#### HISTORIC AND DESIGN REVIEW COMMISSION May 17, 2017

HDRC CASE NO:	2017-110	
ADDRESS:	313 E MISTLETOE	
LEGAL DESCRIPTION:	NCB 863 BLK LOT 4	
ZONING:	R-6 H	
CITY COUNCIL DIST.:	1	
APPLICANT:	Mark Sembera	
<b>OWNER:</b>	Christine Sembera	
<b>TYPE OF WORK:</b>	Remove damaged facade elements, extend roofline, addition, exterior	
	modifications

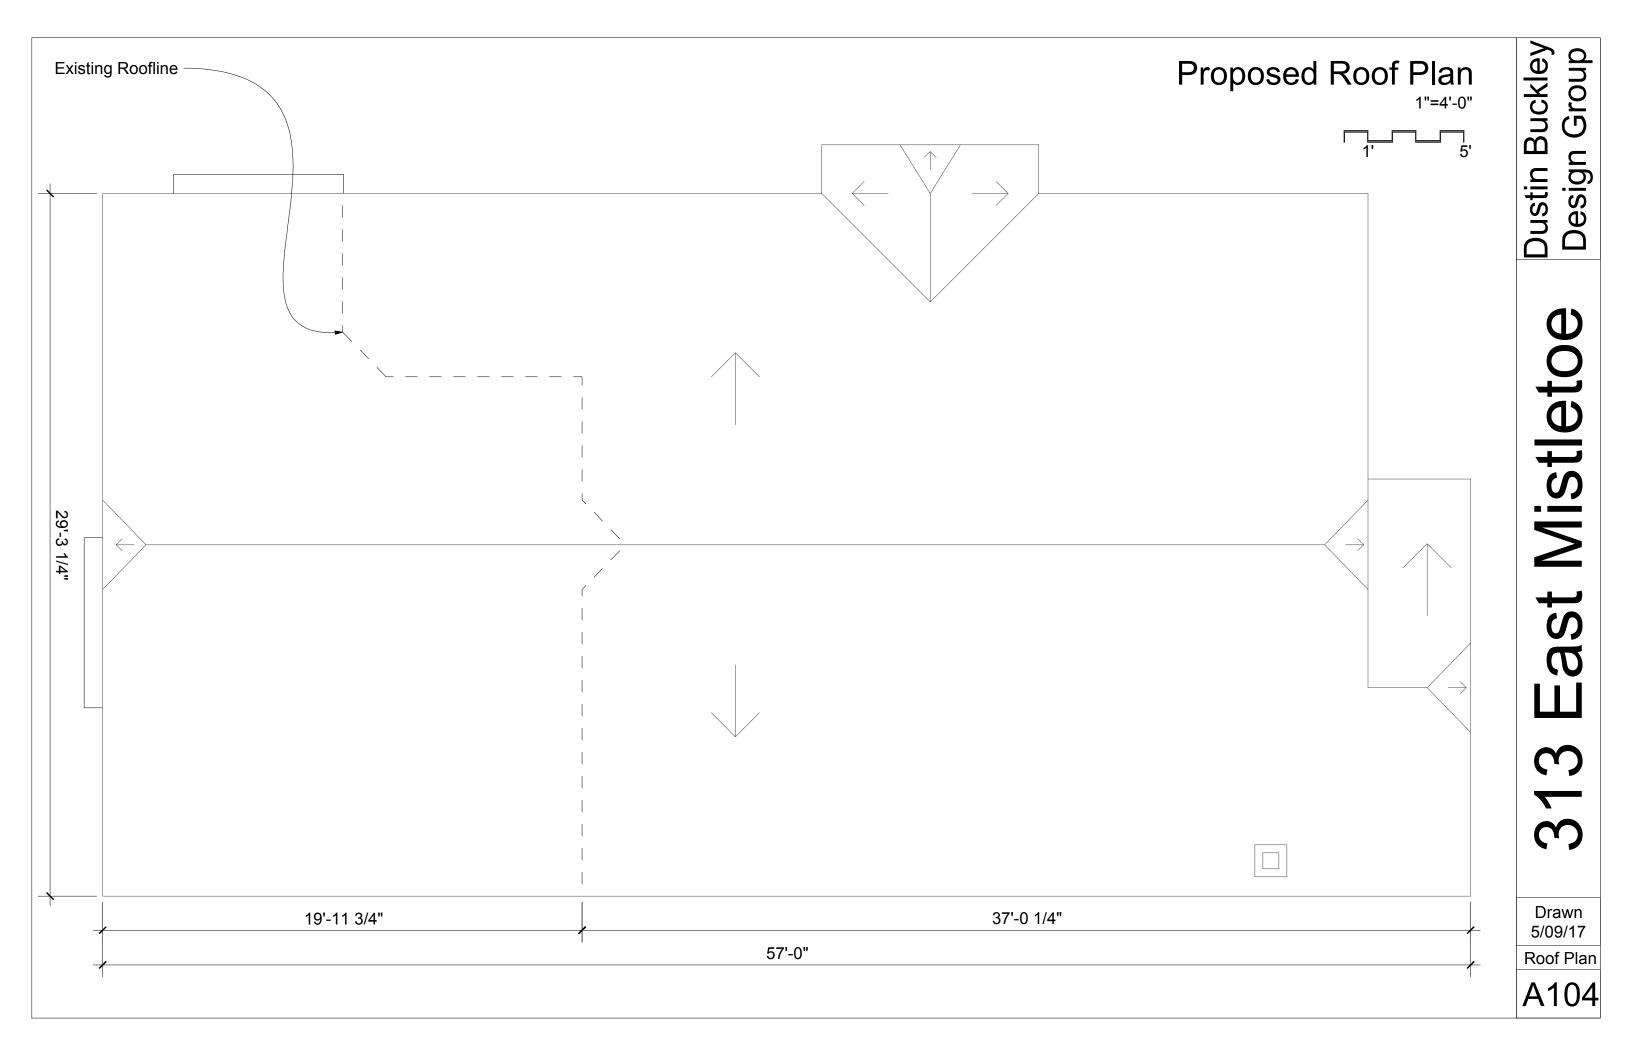
- d. ROOF– The proposal includes extending the existing primary rear roofline towards the rear to add additional interior square footage. Presently, a smaller and subordinate gable structure exists at the northeast corner of the addition. Staff and the DRC have determined this element to be a character defining feature of the style of the home. A previous proposal by the applicant proposed removing this element. The present proposal will retain the existing gable structure by integrating the extended roofline into the northwest corner of the rear gable, and retaining the remaining form and material as is. However, the north elevation indicates that the subordinate gable with be concealed from view with new wood plank siding. Staff finds the overall addition proposal generally acceptable, but does not find the concealing of a character defining feature consistent with the guidelines.

- f. MATERIAL TRANSITIONS According to the Historic Design Guidelines, additions should provide a clear visual distinction between old and new forms. The applicant received an Administrative Certificate of Appropriateness to remove non-original asbestos siding and to restore existing original wood lap siding underneath. The applicant has proposed to use woodlap siding with a 6" profile on the new addition as an extension of the current material conditions, with a vertical trim piece on the sides to indicate where the addition begins relative to the existing structure. Staff finds the material consistent with the guidelines but finds the 6" profile incompatible with the exterior structure.

- i. That the siding be removed from the gable of the rear addition so the existing subordinate gable is visible. The applicant must submit final drawings to staff for approval prior to receiving a Certificate of Appropriateness.
- ii. That the woodlap siding on the addition match the profile of the existing woodlap siding.
- iii. That the new standing seam roof follow the Checklist for Metal Roofs in the Historic Design Guidelines. The roof should feature panels that are 18 to 21 inches wide, seams are 1 to 2 inches in height, a crimped ridge seam or low profile ridge cap and a standard galvalume finish.
- 3. Staff recommends approval of the French door installation and salvaged window installation based on finding g.

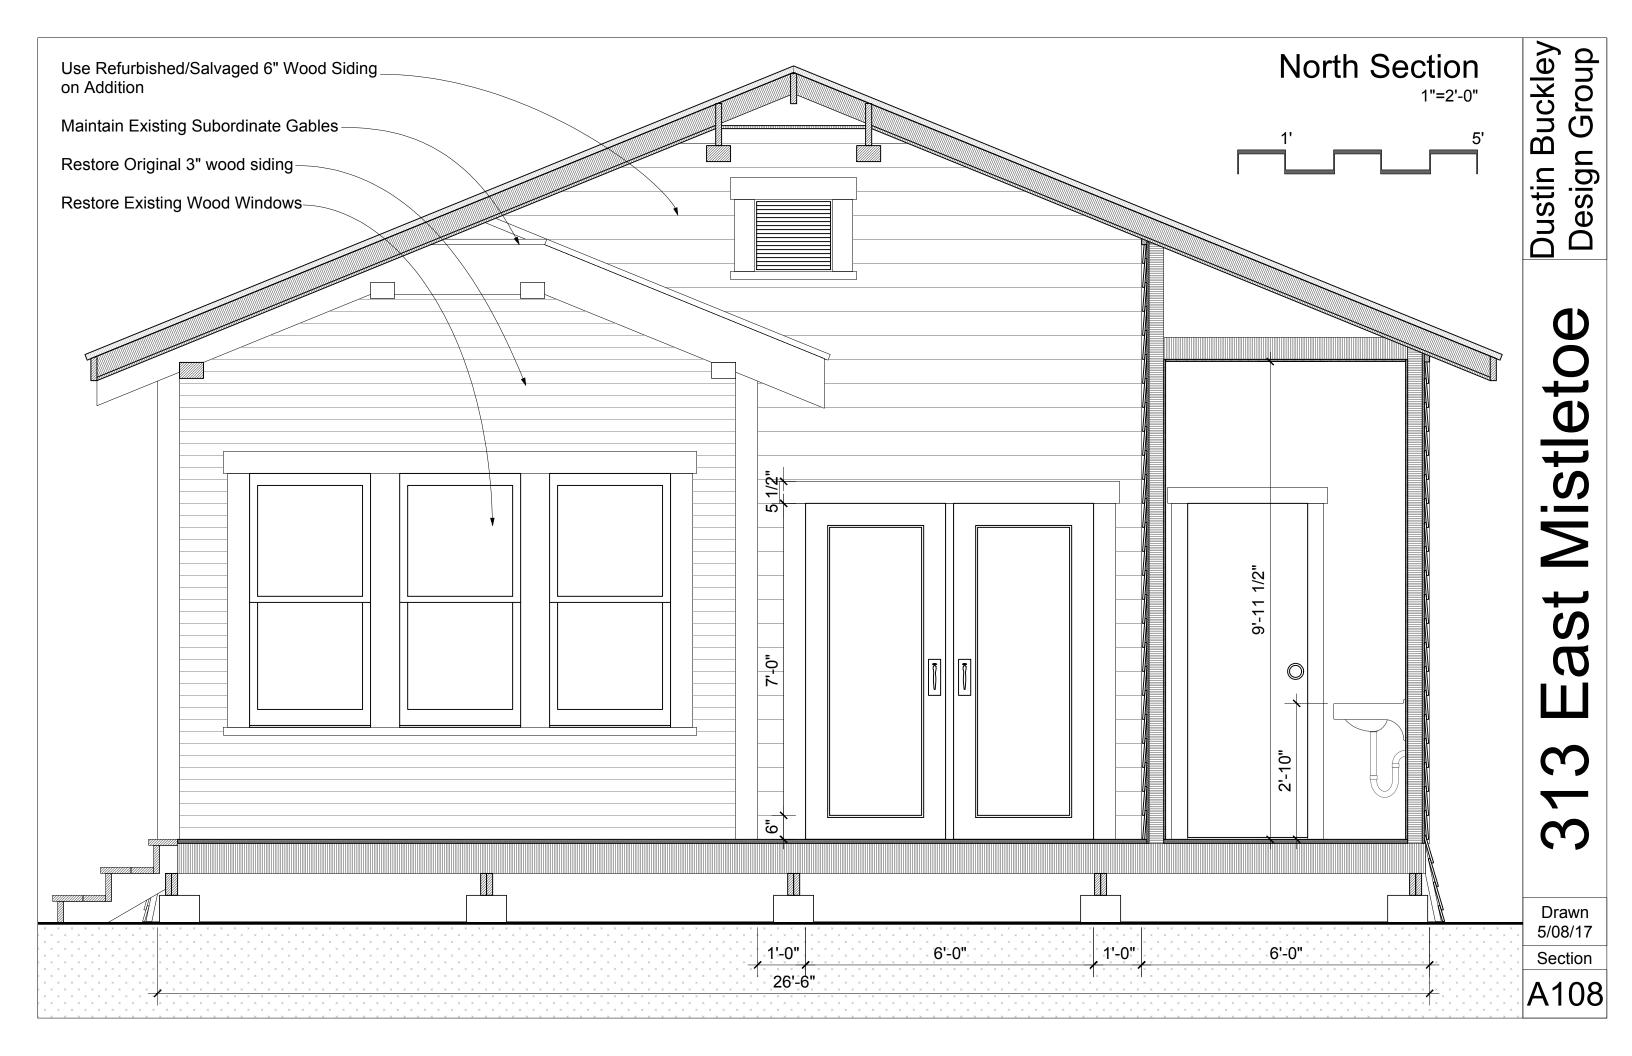
- g. FENESTRATION MODIFICATIONS The applicant has proposed to reuse an existing original interior wood window to be removed for the addition in the rear elevation of the addition. Additionally, the applicant has
